Thank you for your letter dated July 21, 2000, in which you requested the Environmental Protection Agency's (EPA's) approval for the elimination of magnesium oxide (MgO) mini-sacks from the Waste Isolation Pilot Plant (WIPP). The elimination of the mini-sacks would result in a fifteen percent reduction in the total amount of MgO that must be placed in the WIPP, in accordance with the WIPP Compliance Certification Application and EPA's certification decision.

MgO Mini-sack Review

**DOE Proposal for
Elimination of MgO Mini-sacks**

Figure 1. Diffusion penetration distance in the WIPP as a function of diffusion time

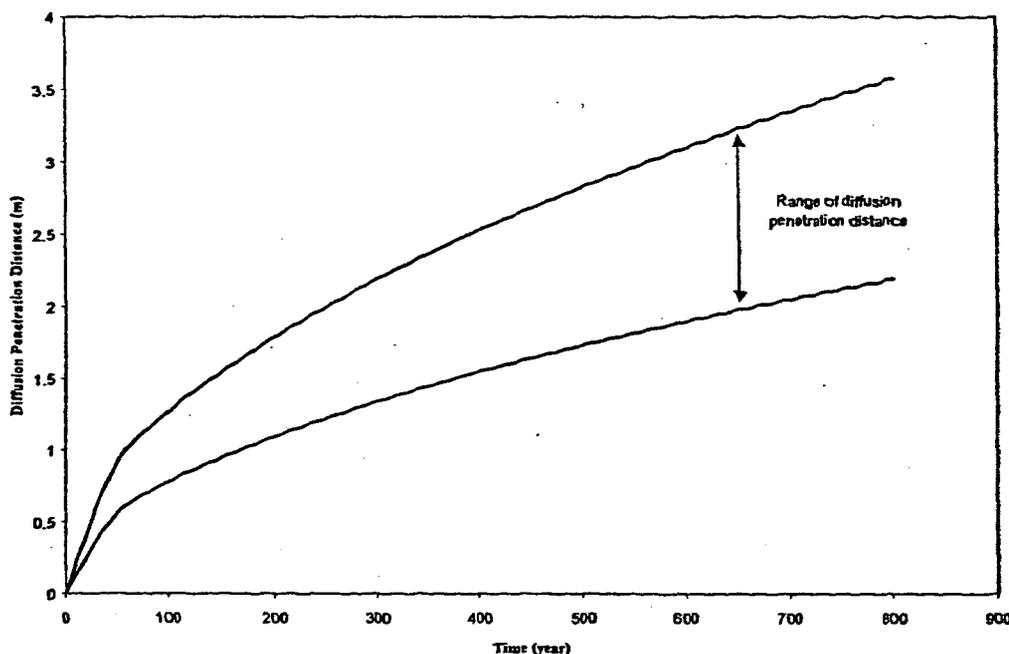
Using Equation (3), the diffusion penetration distance in the WIPP can be calculated as a function of diffusion time, as shown in Figure 1.

where V_{ϕ} is the pore volume in a waste panel; and F is the rate of brine flow up to the Culobra formation through a borehole. From the CCA calculations, the pore volume in a waste panel after room closure ranges from 2,500 to 7,000 m³ (Helton et al., 1998, p.8-50), and the maximum flow rate is 5.5 m³/year (Helton et al., 1998, p.8-69). Using these values, $T_{residence}$ is estimated to be > 450 years. Over this time scale, according to Equation (3) and Figure 1, molecular diffusion alone can mix brine composition effectively at least over a distance of 1.6 m.

where h_0 and ϕ_0 are the initial height of waste stacks and the initial porosity of wastes, which are assumed to be 4 m and 0.88, respectively, in the CCA. For $\phi = 0.4 - 0.7$, h is estimated to be 0.8 to 1.4 m, which is less than the calculated diffusion penetration distance. Since MgO super-sacks are directly placed on the top of waste stacks in the current waste emplacement configuration, it can be concluded that molecular diffusion alone can effectively mix brines with super-sack MgO (in a vertical direction) without the presence MgO mini-sacks. In other words, the elimination of MgO mini-sacks will not affect MgO accessibility by brine in the WIPP.
